Improving the Woodbine Cycle Track: Updated Recommendations

By Adam Smith

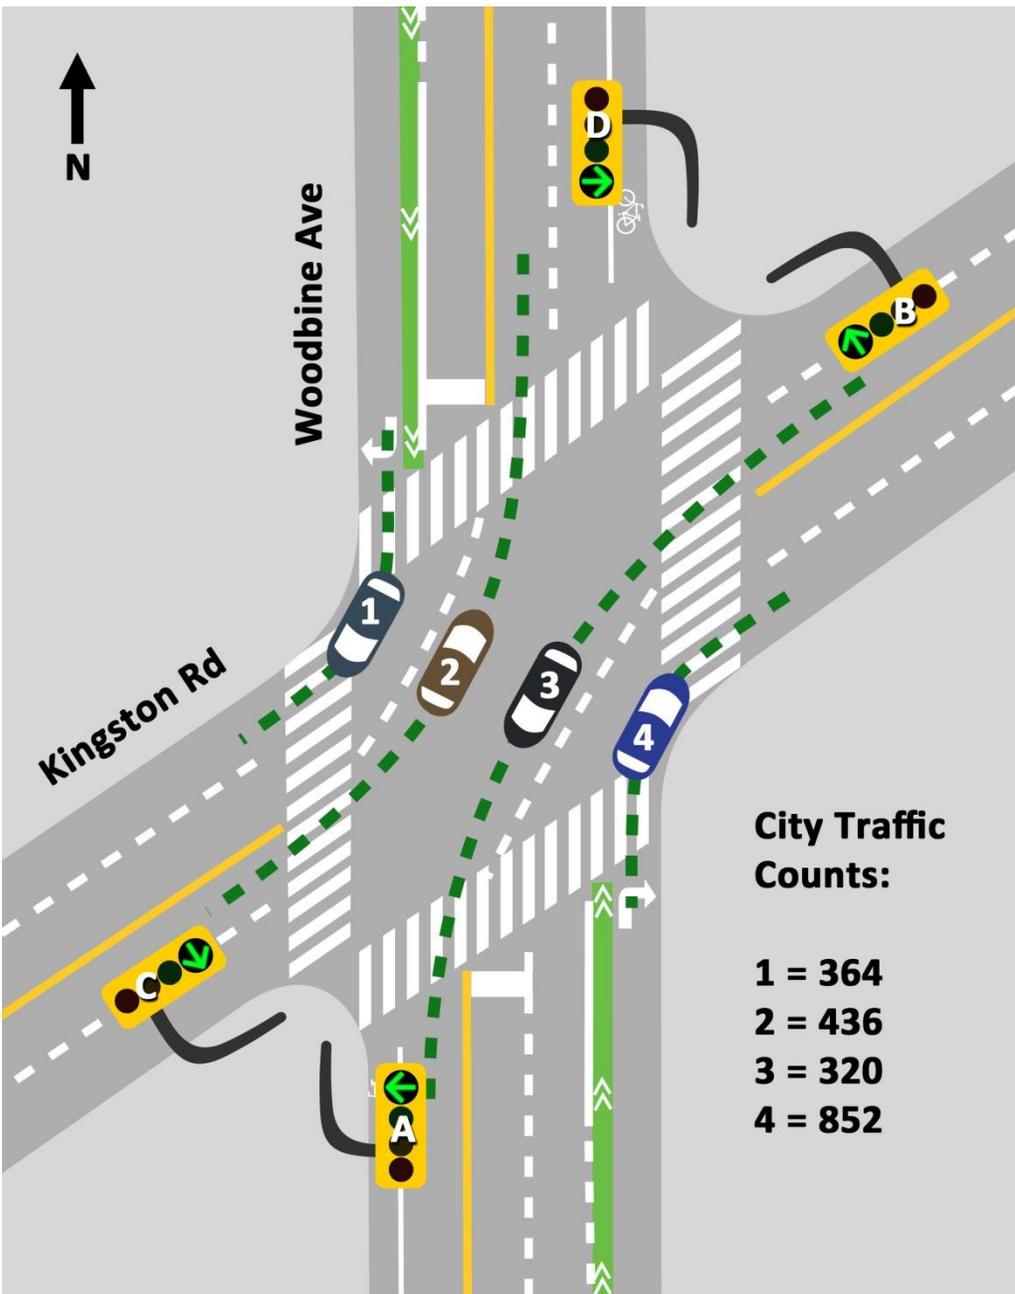
There is much greater eastbound traffic on Kingston during evening rush hour, yet the westbound side gets a full advance every single light, and observations at the intersection show there are times there is no westbound traffic at all. The city's reasoning is not about the westbound or south-turning traffic, but rather the right turn advance (D) from northbound Woodbine onto eastbound Kingston that runs at the same time as the left turn advance from westbound Kingston onto southbound Woodbine (C). There's a lot of traffic coming up Woodbine from the Lakeshore to turn east on Kingston, but according to the city's latest traffic counts there is only 32% less traffic waiting to turn west on Kingston (1) and north on Woodbine (2), than there is turning south on Woodbine (3) and east on Kingston (4). This creates inefficiency at the intersection that could be improved by enabling other directions to advance at the same time.

Adding a southbound right turn signal (A) and an eastbound left turn signal (B) at Kingston and Woodbine to run concurrent with the westbound left turn signal (C) and northbound right turn signal (D) during evening rush hour would greatly improve traffic flows. The volume of eastbound traffic is considerable, higher than any other direction at that time. Allowing more eastbound left turns will aid eastbound traffic in moving through the intersection, and due to lighter volumes in the other direction westbound will not have a negative impact. In this case it is not a zero sum game because the westbound timing is not needed. Lastly, while the argument can be made that because there are no dedicated left turn lanes on Kingston the left turn advances might not have the intended effect if a person wanting to go straight through ends up at the front,

observations at the intersection show that cars anticipate the need to turn left and tend to line up accordingly, not to mention left-turning cars (especially eastbound) that get stuck at the light waiting to turn.
